**Response to Nevada Division of Environmental Protection (NDEP) Comments dated December 13, 2008, regarding *Groundwater Flow Model Calibration Report*, dated November 4, 2008
NDEP Facility ID# H-000688**

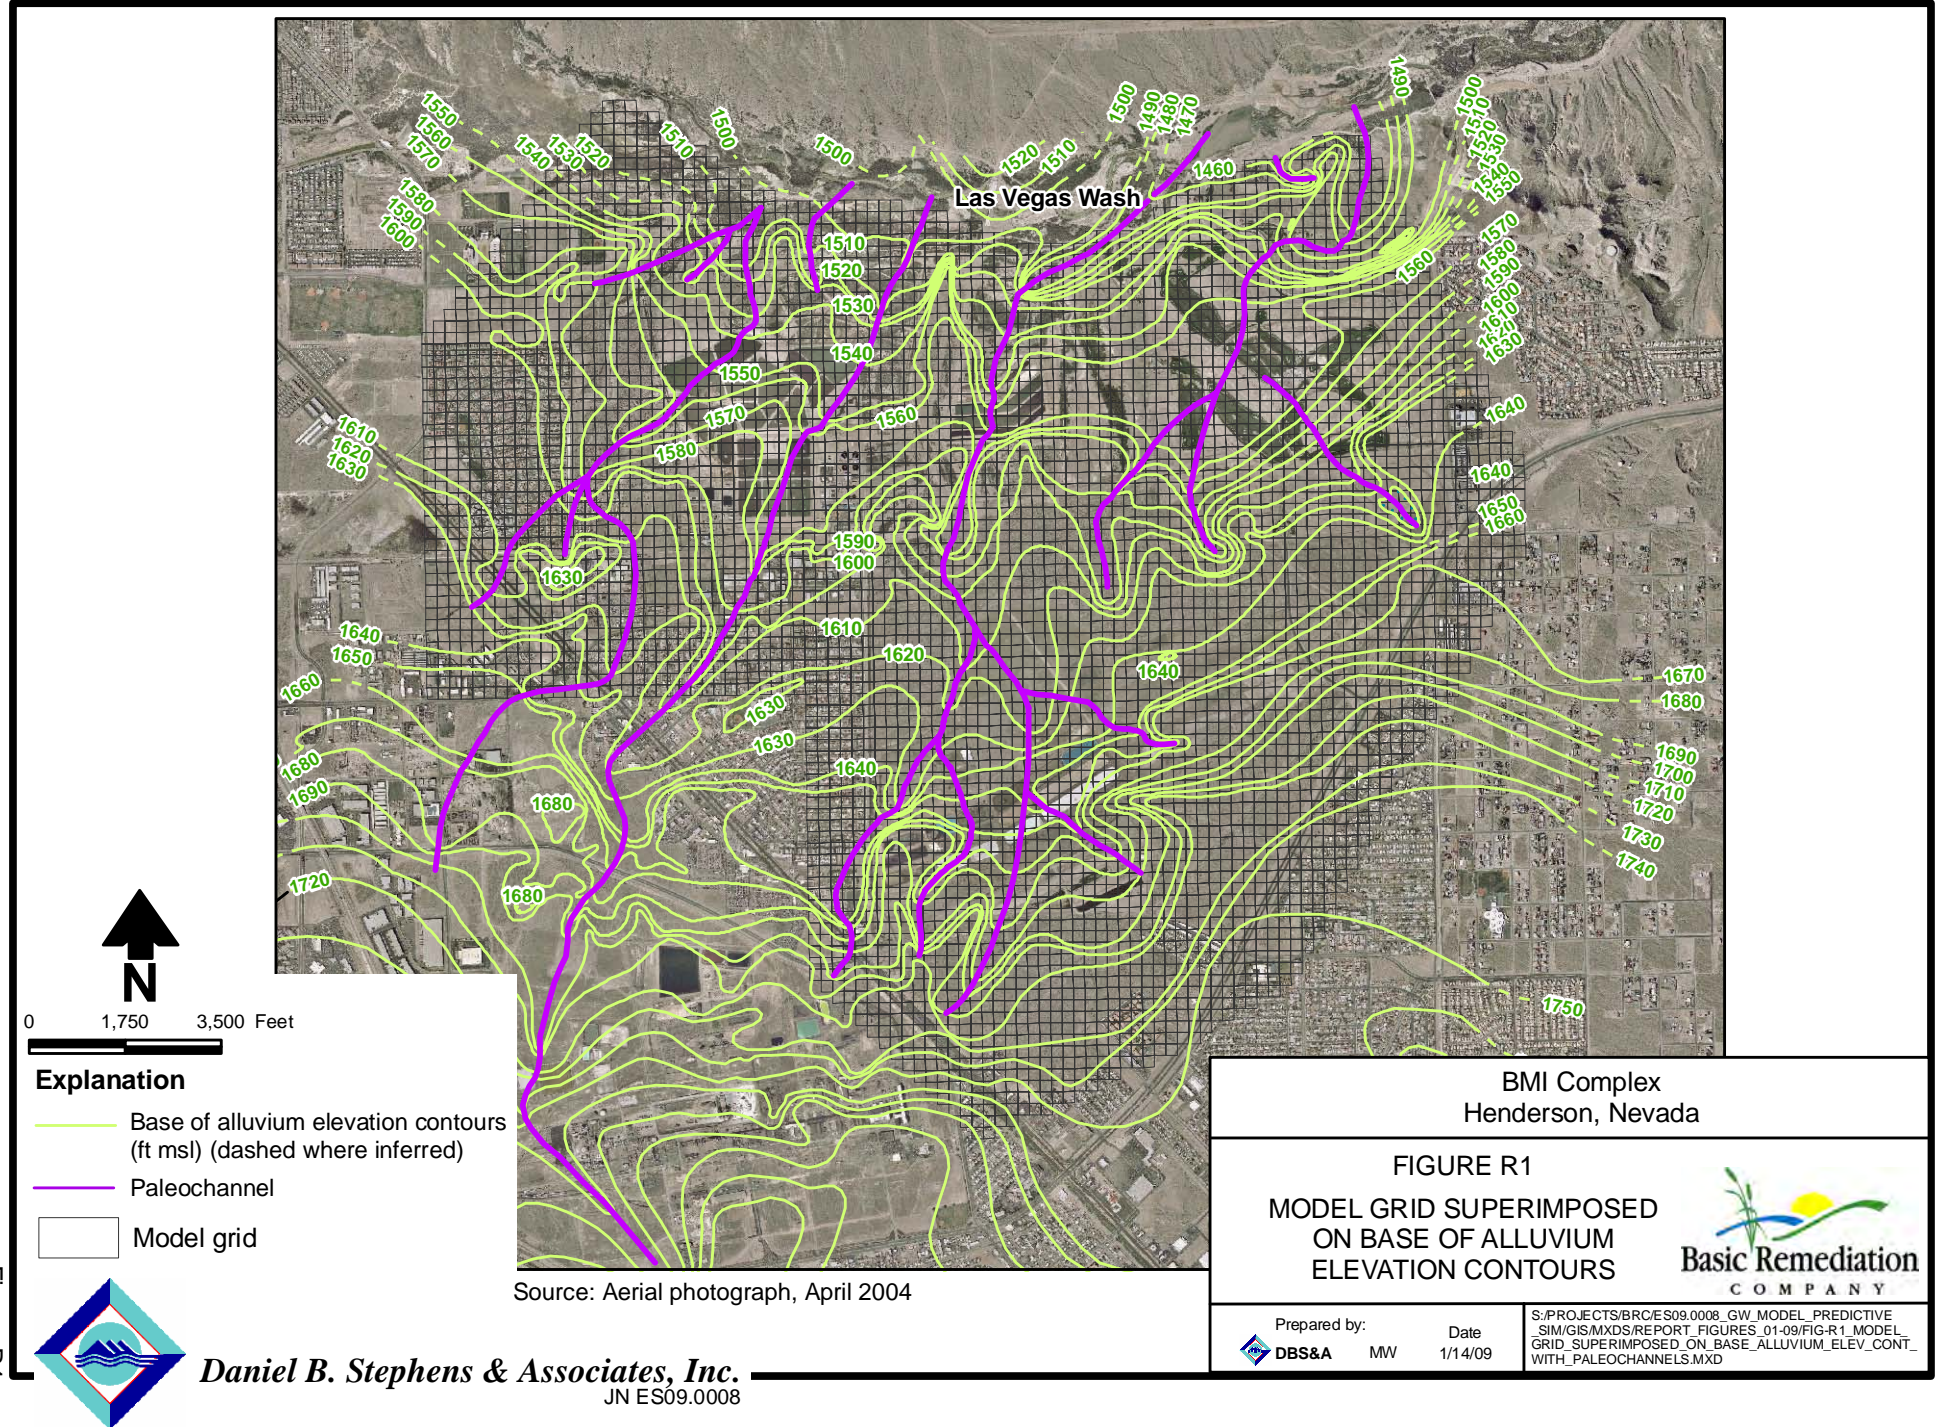
16. Figure 8, please include traces of the paleochannels on this figure.

Response: The requested figure is attached as Figure R1.

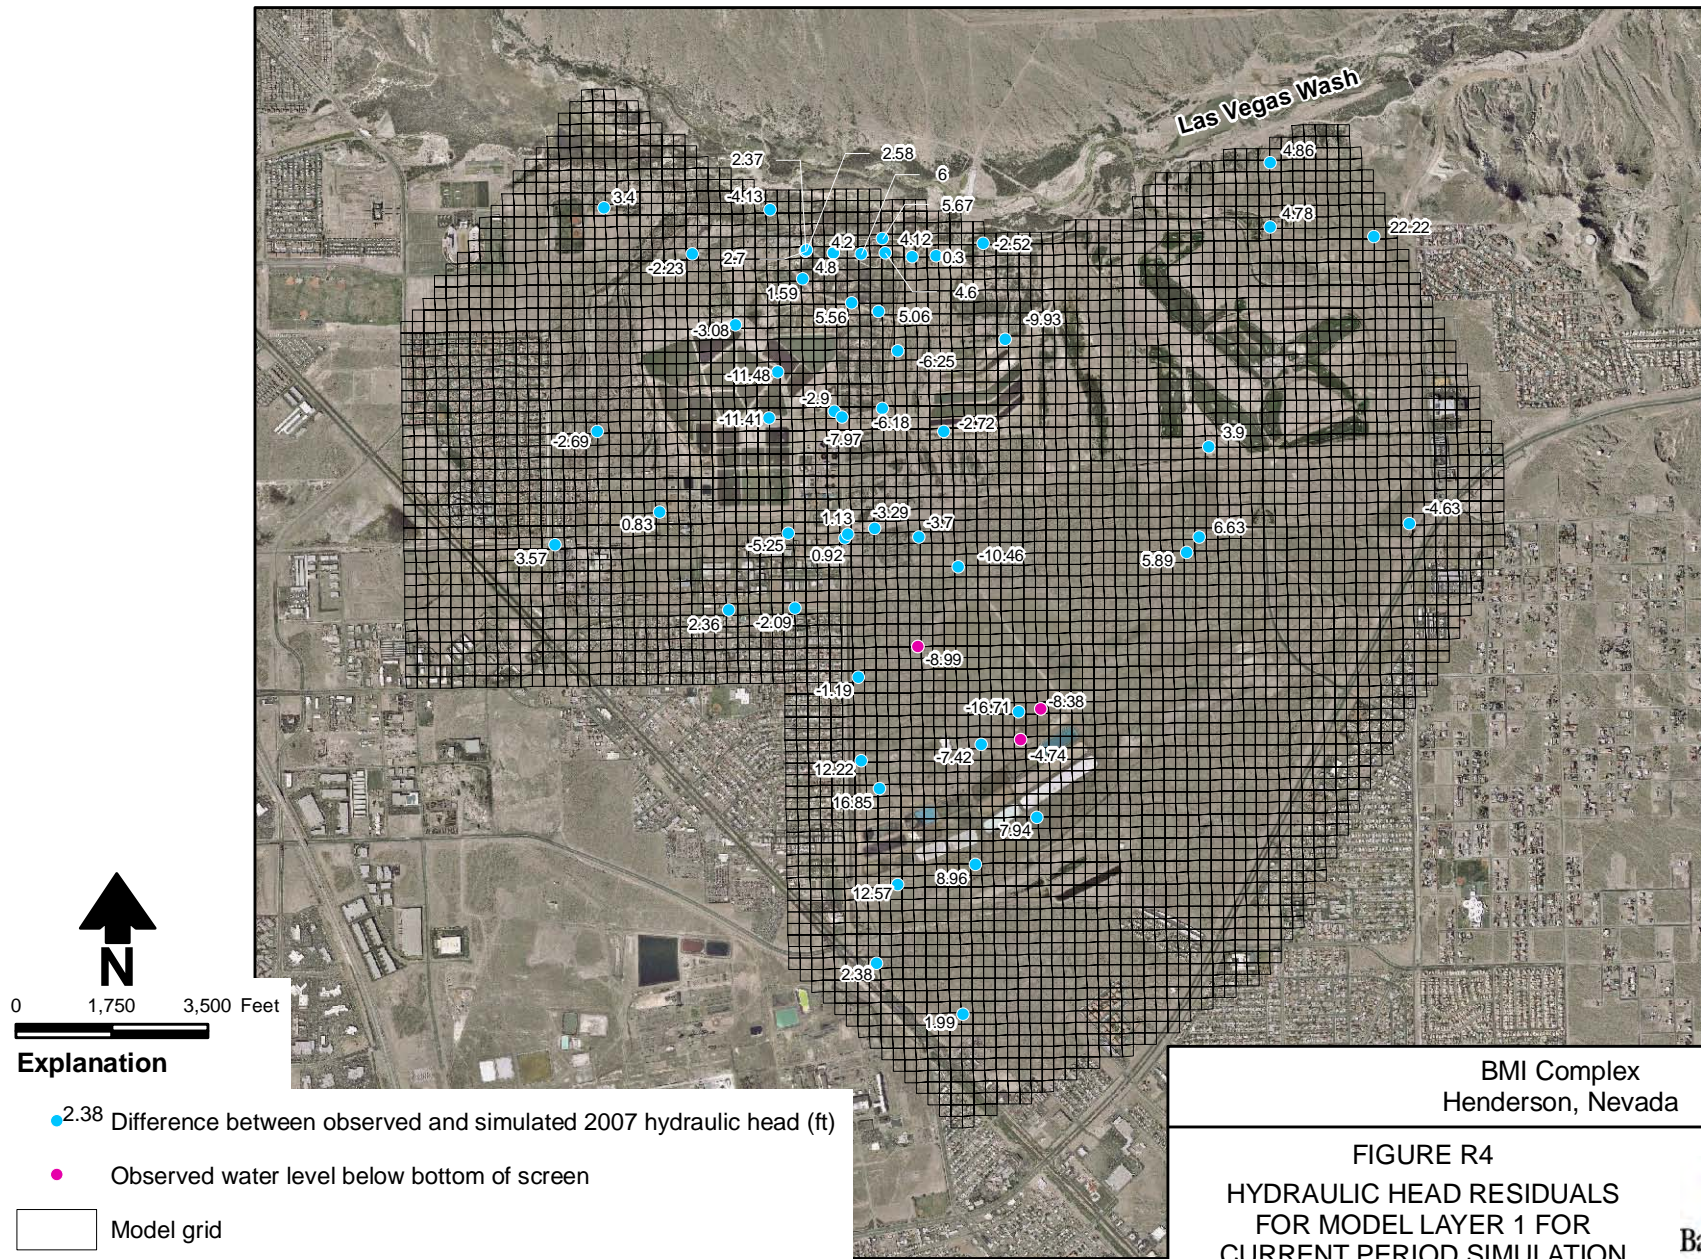
17. Figures 13 and 16, the NDEP notes that the improved MAE and RMSE statistical measures over the August 7, 2008 presentation. Additional figures are requested, corresponding to these figures, showing head residuals labeled on a base map of target wells. Please also include on the Layer 1 figure contours of aquifer thickness. This will be helpful in terms of identifying areas of inordinately high residuals with respect to aquifer thickness and areas of concern for predictive scenarios. If the highest residuals are proximal to areas of relatively thin aquifer, or proximal to areas of greatest concern for water table rise in predictive scenarios, then the model may not be achieving its objective.

Response: The requested figures are attached as Figures R3 through R8. A brief description of each figure follows:

- a. Figure R3 - Location of observation wells for model layer 1 used in model calibration.
- b. Figure R4 - Map of residual between observed and simulated water levels for layer 1.
- c. Figure R5 - Map of Qal observed saturated thickness.
- d. Figure R6 - Map of Qal observed saturated thickness superimposed on base elevation of Qal and delineated paleochannels.
- e. Figure R7 - Location of observation wells for model layer 2 used in model calibration.
- f. Figure R8 - Map of residual between observed and simulated water levels for layer 2.

A contour map of Qal saturated thickness was not constructed as requested by NDEP because the available information is insufficient to construct such a map across large portions of the site. The available data clearly illustrate larger saturated thickness in paleochannels, and reduced (and in many areas zero) saturated thickness outside of paleochannels (Figure R6). Note that the figures provided with this response are based on the observation well information used for the current period (2007) model calibration, which are listed in Table 4 of the groundwater model report.

Additional well information related to the delineation of areas where the Qal is believed to be dry provided in Figure 14 of the modeling report is also posted on Figures R5 and R6. Although these additional points from Figure 14 were used to compare simulated regions of dry Qal with observed regions of dry Qal, they were not included in the model calibration statistics. If these points were included in the model calibration statistics, the mean error, mean absolute error and root mean squared error would be further reduced.
